Illinois Tollway Standard Drawing Revisions

Section H		Roadway Lighting	
Drawing	Modification Summary	Effective: 03-01-2026	
H1-14	LIGHT STANDARD FOUNDATION		
Sheet 1	Alternate anchor bolt detail added.

EXTERIOR CONTROL CONSOLE DETAILS

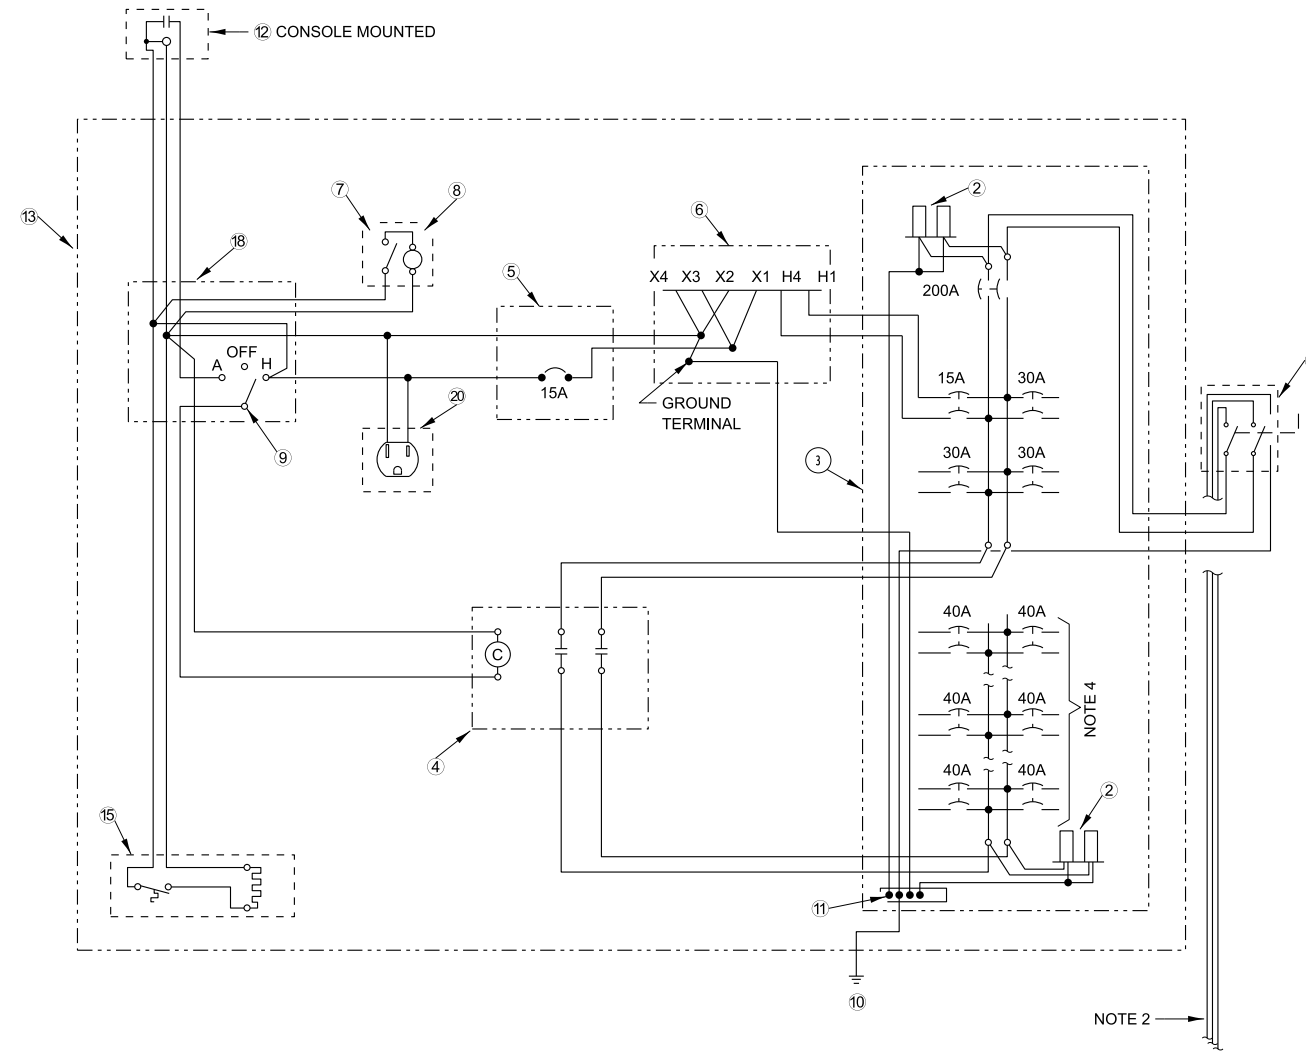
REVISIONS	
DATE	DESCRIPTION
03-01-2026	ADDED NOMENCLATURE FOR LABELING AN EXTERIOR CONTROL CONSOLE.
03-01-2018	REMOVED CONTRACTOR RELAY, ADDED GCFI OUTLET.
03-31-2017	REMOVED METER HOUSING.
03-31-2016	REVISED NOTE 2.

EXTERIOR CONTROL CONSOLE FOUNDATION DETAILS

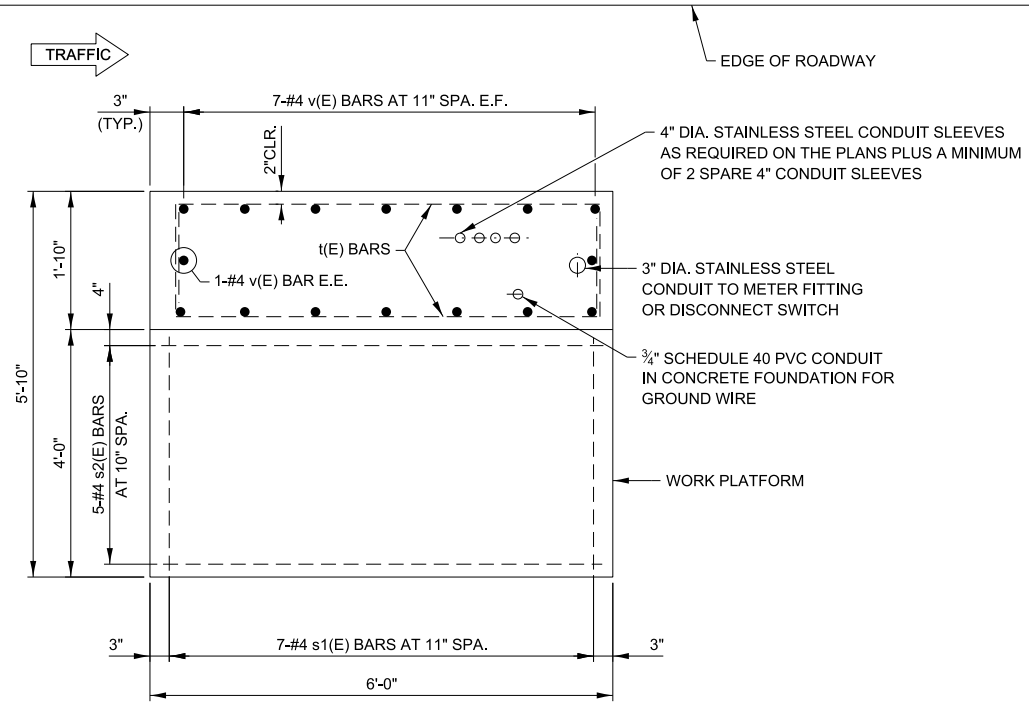
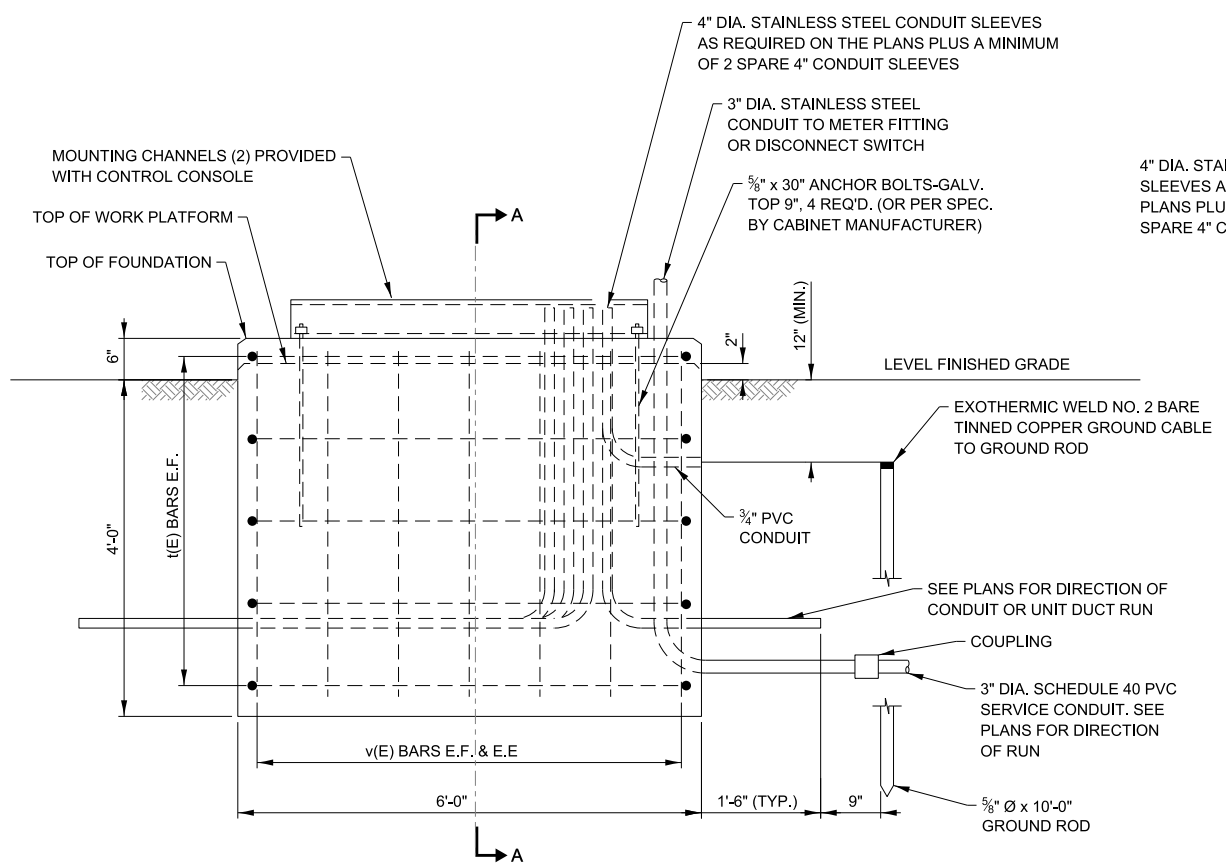
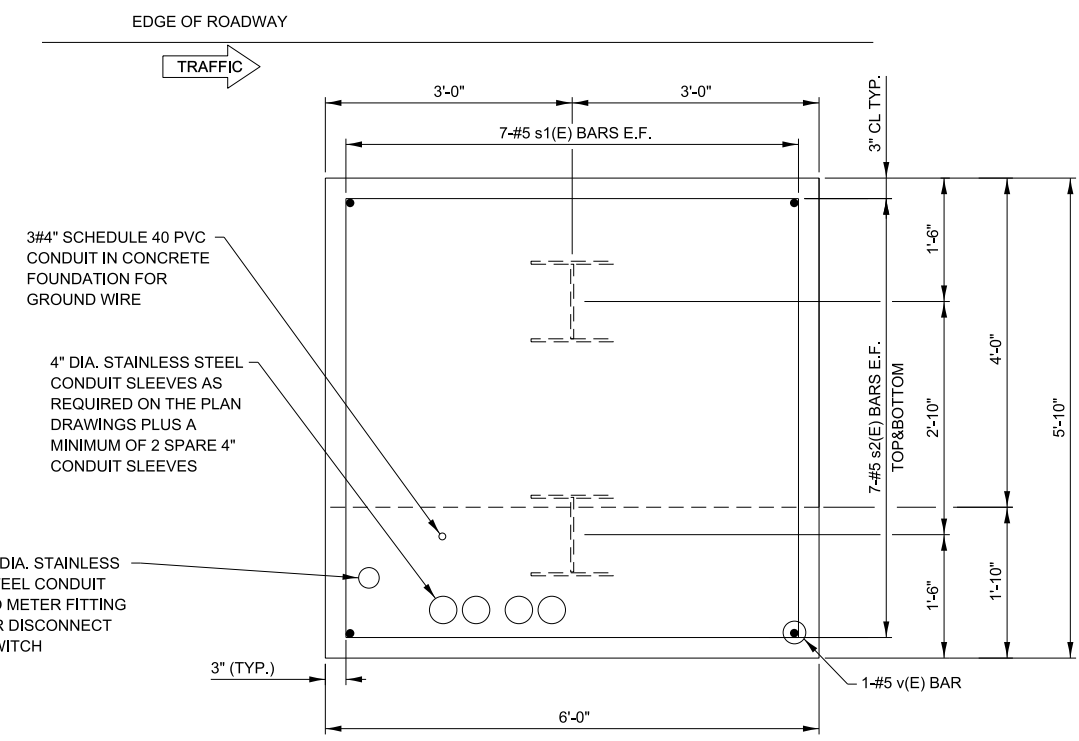
REVISIONS	
DATE	DESCRIPTION
03-01-2026	ADDED NOTES 9, 10, 11, AND 12. PILE SPACING ADDED AND BILL OF MATERIAL UPDATED TO INCLUDE HP PILE PAY ITEMS, CLASS "SI" CONCRETE QUANTITY REVISED TO 5.5 CU. YD., VERTICAL DIMENSION REVISED TO 4'-4".

8. FOR TYPE B FOUNDATION REINFORCEMENT, WELDED WIRE MESH 6X6 D16, Fy=60 KSI CAN BE USED.
9. INCREASE THE PILES LENGTHS TO ALLOW A MINIMUM OF 10' PENETRATION BELOW SLOPE FILL.

10. PILE FACTORED LOAD IS 16 KIPS/PILE. A GEOTECHNICAL INVESTIGATION MAY BE REQUIRED BASED ON SITE CONDITIONS.
11. CONTRACTOR IS ALLOWED TO SUBMIT ALTERNATIVE FOUNDATION DESIGN FOR TOLLWAY REVIEW AND APPROVAL.

12. THE FOUNDATION DETAILS SHOWN ARE BASED ON THE PRESENCE OF MOSTLY COHESIVE SOIL CONDITIONS (SILTY OR SANDY CLAY), WITH AN AVERAGE UNCONFINED COMPRESSIVE STRENGTH (QU) > 1.25 TON/SQ. FT. WHICH MUST BE DETERMINED BY PREVIOUS SOIL INVESTIGATIONS AT THE JOBSITE. WHEN OTHER CONDITIONS ARE INDICATED, THE BORING DATA SHALL BE INCLUDED IN THE PLANS AND THE FOUNDATION DIMENSIONS SHOWN SHALL BE THE RESULT OF SITE SPECIFIC DESIGNS. IF CONDITIONS ENCOUNTERED IN THE FIELD ARE DIFFERENT THAN THOSE INDICATED, THE CONTRACTOR SHALL NOTIFY THE ENGINEER TO DETERMINE IF THE FOUNDATION DIMENSIONS NEED TO BE MODIFIED.

TYPE B CONTROL CONSOLE FOUNDATION

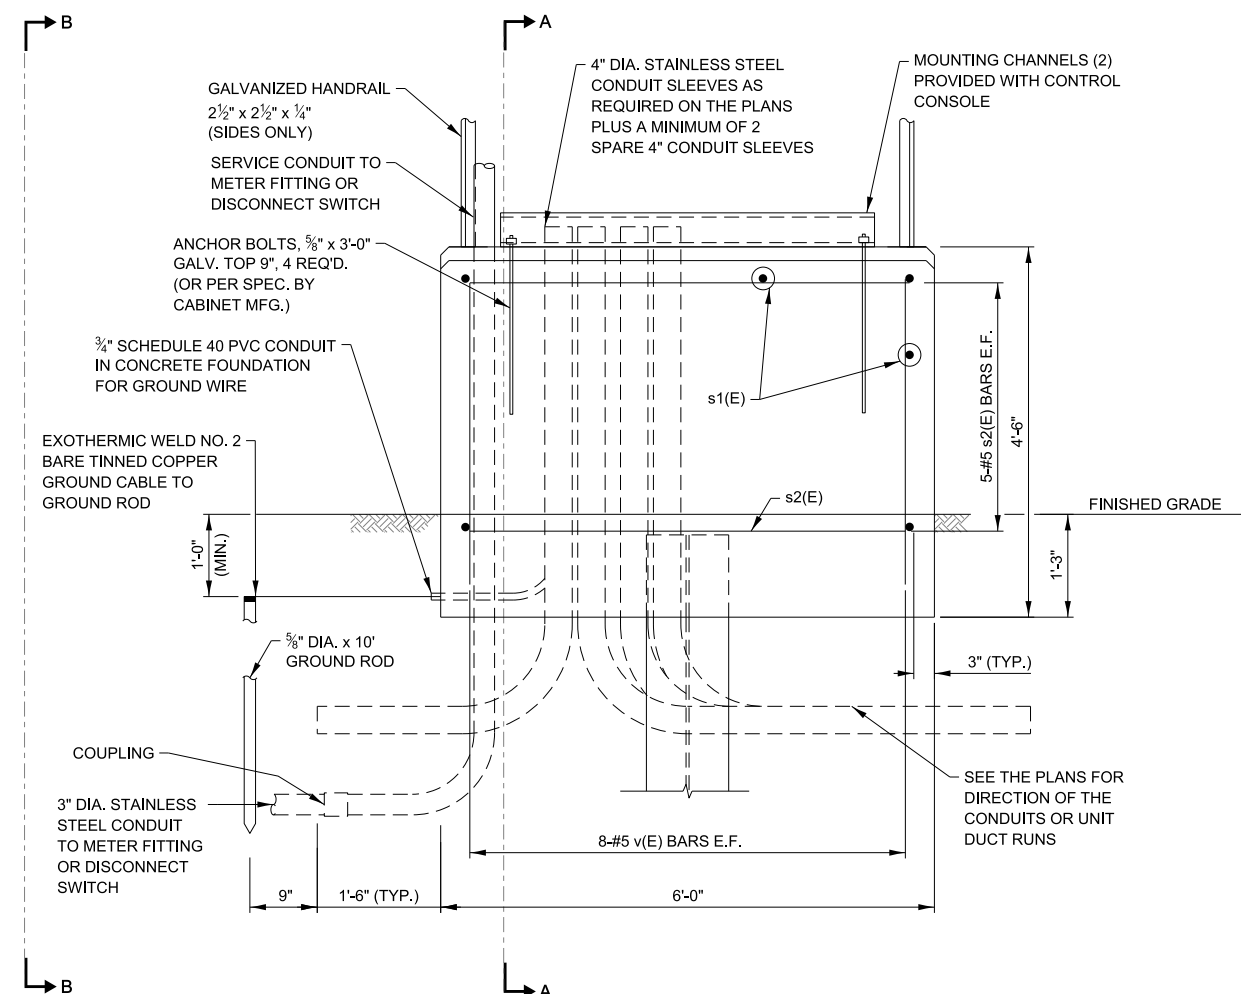
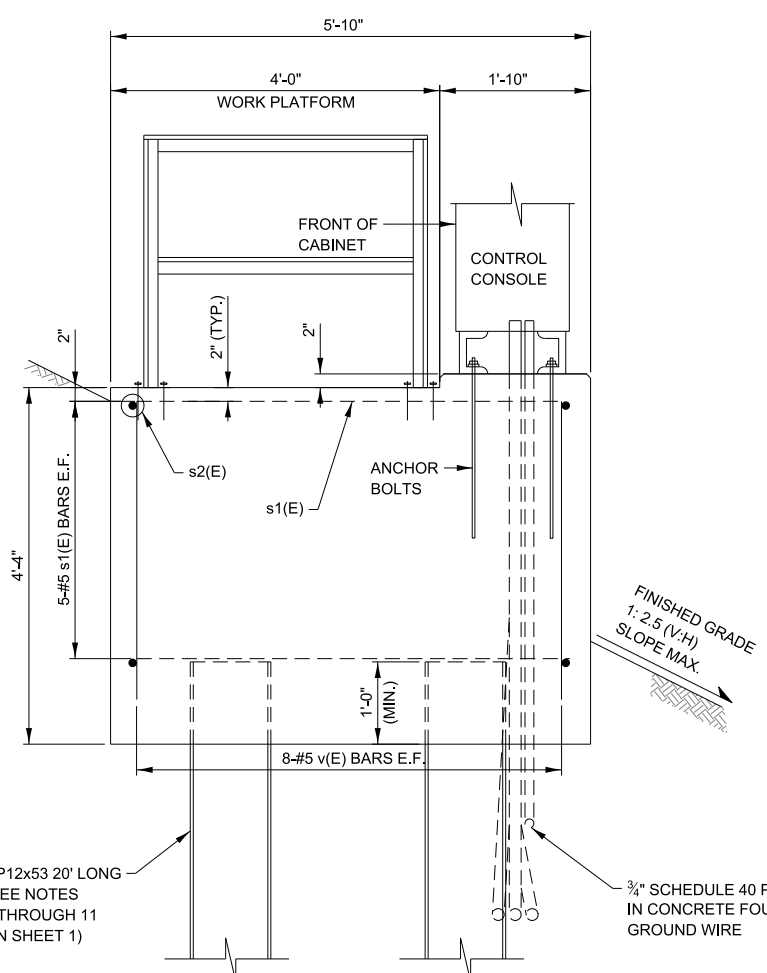
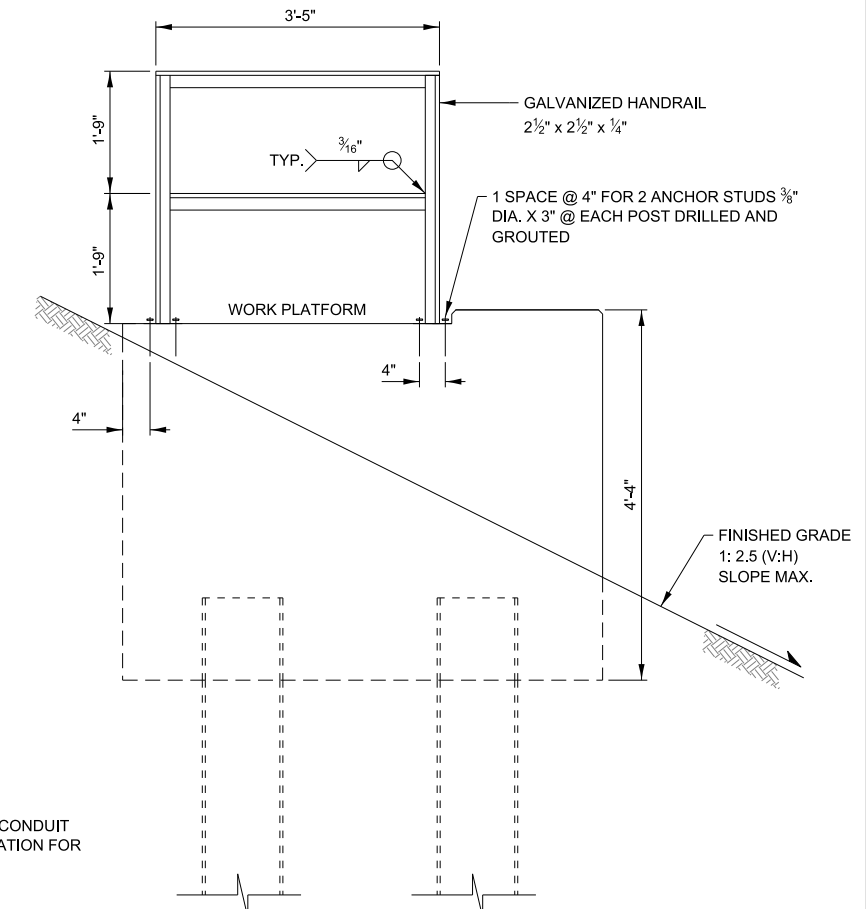
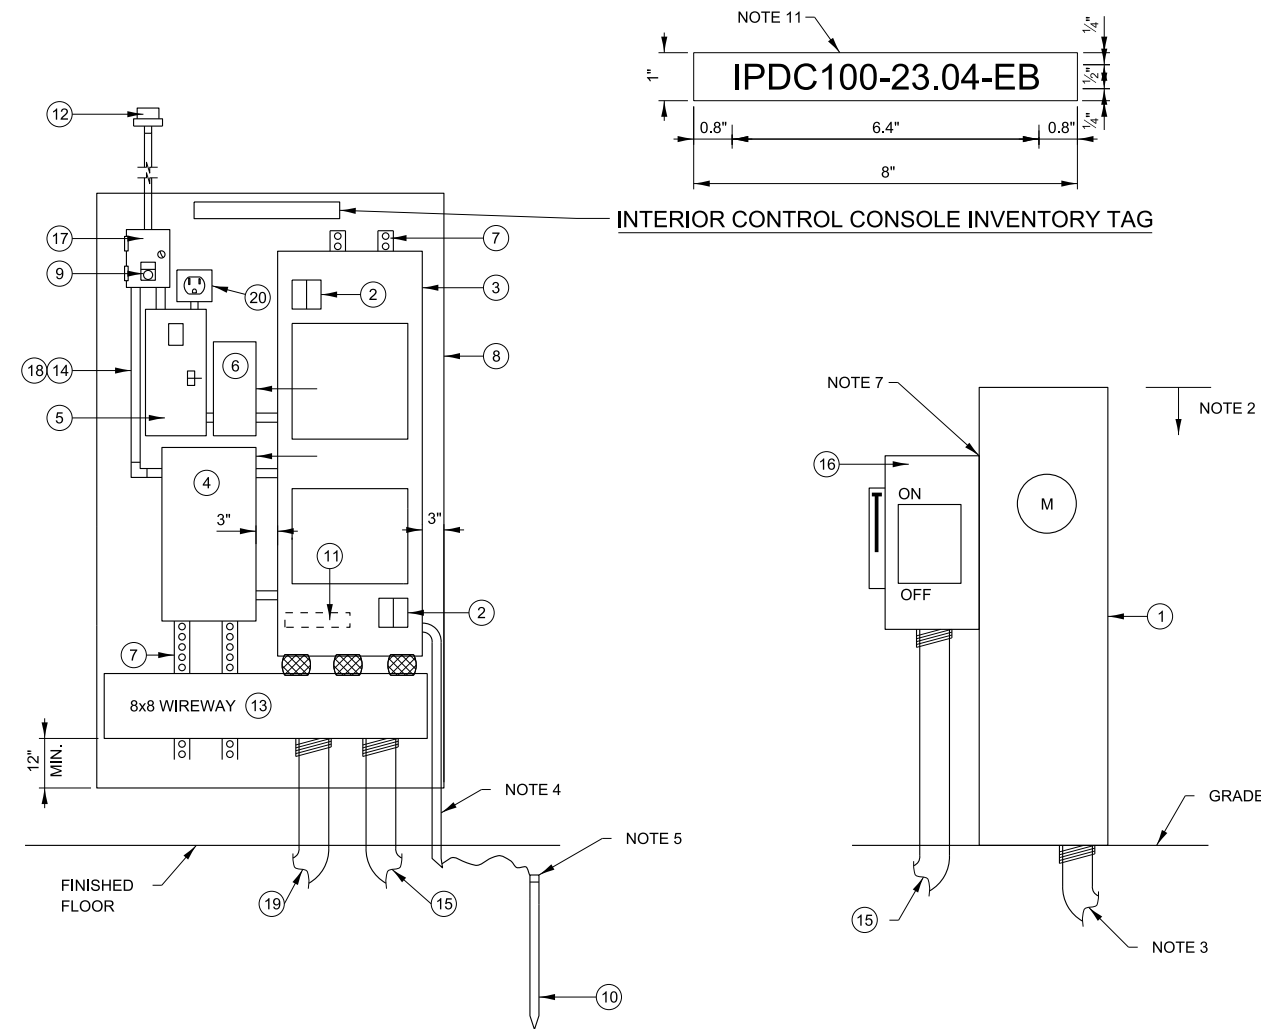
Sheet 1	Note 9, 10, 11, and 12.		
Sheet 2	Pile spacing added and Bill of Material updated to include HP Pile pay items.		
	Class "SI" concrete quantity revised to 5.5 Cu. Yd. Vertical dimension revised to 4'-4".		
	Added reference to notes 9, 10 and 11 on the Section A-A detail.		
H8-04	INTERIOR CONTROL CONSOLE DETAILS

BILL OF MATERIAL		
DESCRIPTION	UNIT	QTY
REINF. BARS, EPOXY COATED	POUND	398
CLASS "SI" CONCRETE	CU. YD.	5.5
FURNISHING STEEL PILES HP12X53	FOOT	40
DRIVING PILES	FOOT	40

INTERIOR CONTROL CONSOLE DETAILS

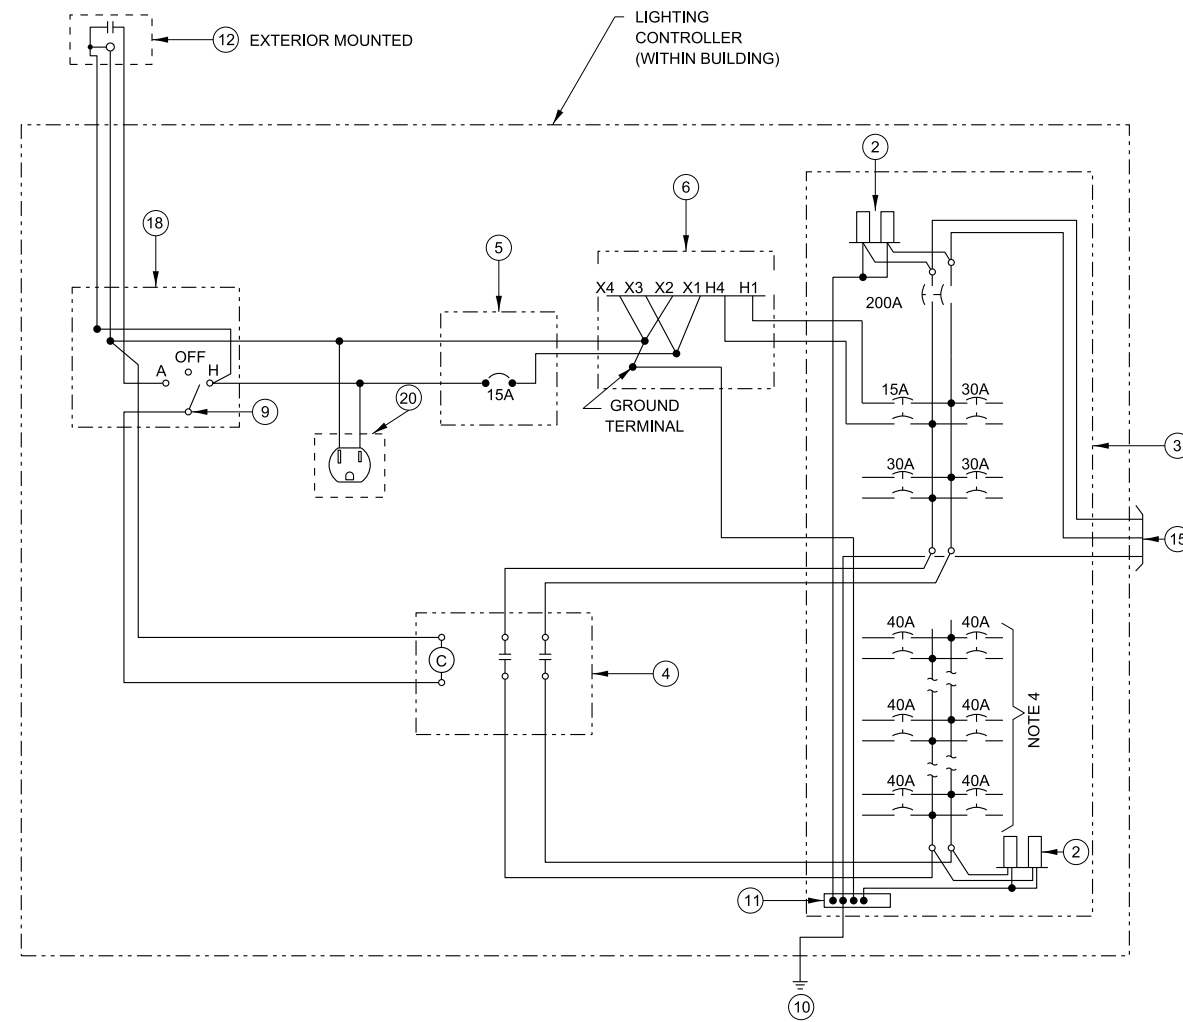
REVISIONS	
DATE	DESCRIPTION
03-01-2026	ADDED NOMENCLATURE FOR LABELING AN INTERIOR CONTROL CONSOLE.
03-01-2018	REMOVED CONTRACTOR RELAY, ADDED GCFI OUTLET
03-01-2017	REMOVED MFR. & PART NUMBERS
03-31-2016	REVISED NOTE 2
